LEXINGTON

SECTION 24

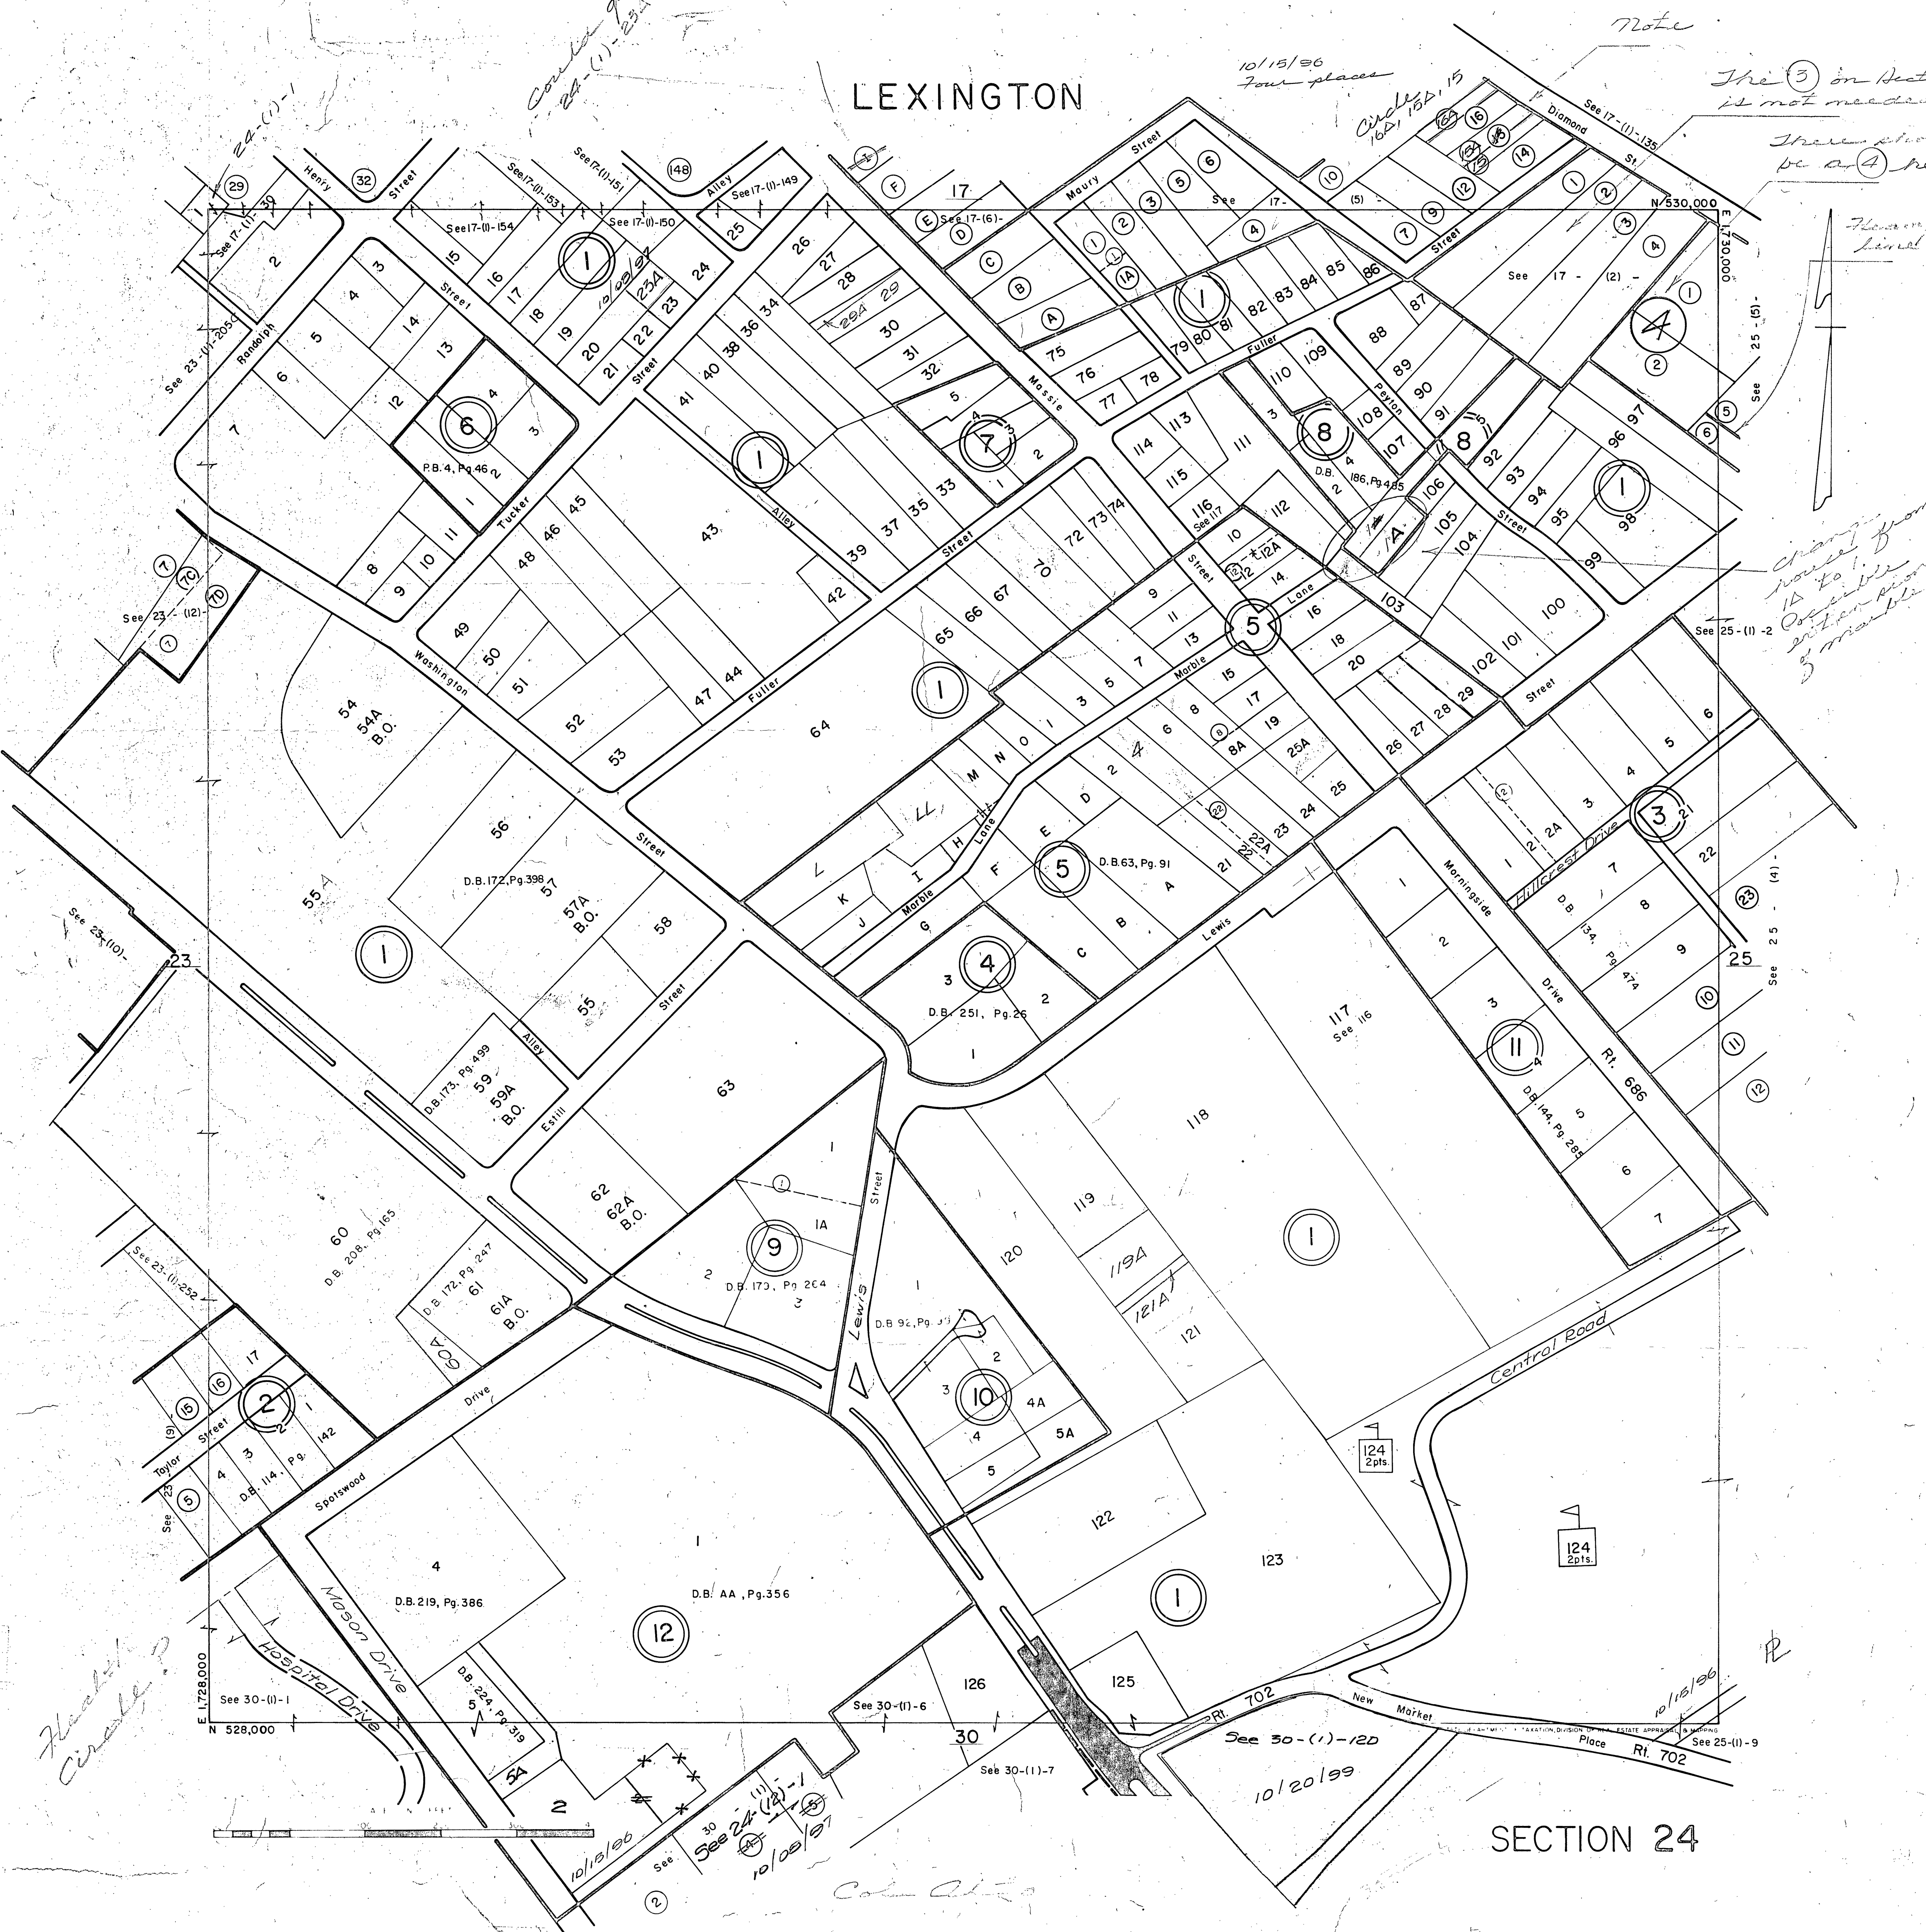
The 3 in Sect is not needed

There should be a 4 per

change from 14 to 1. Possible within 5 months

10/15/96 Four places
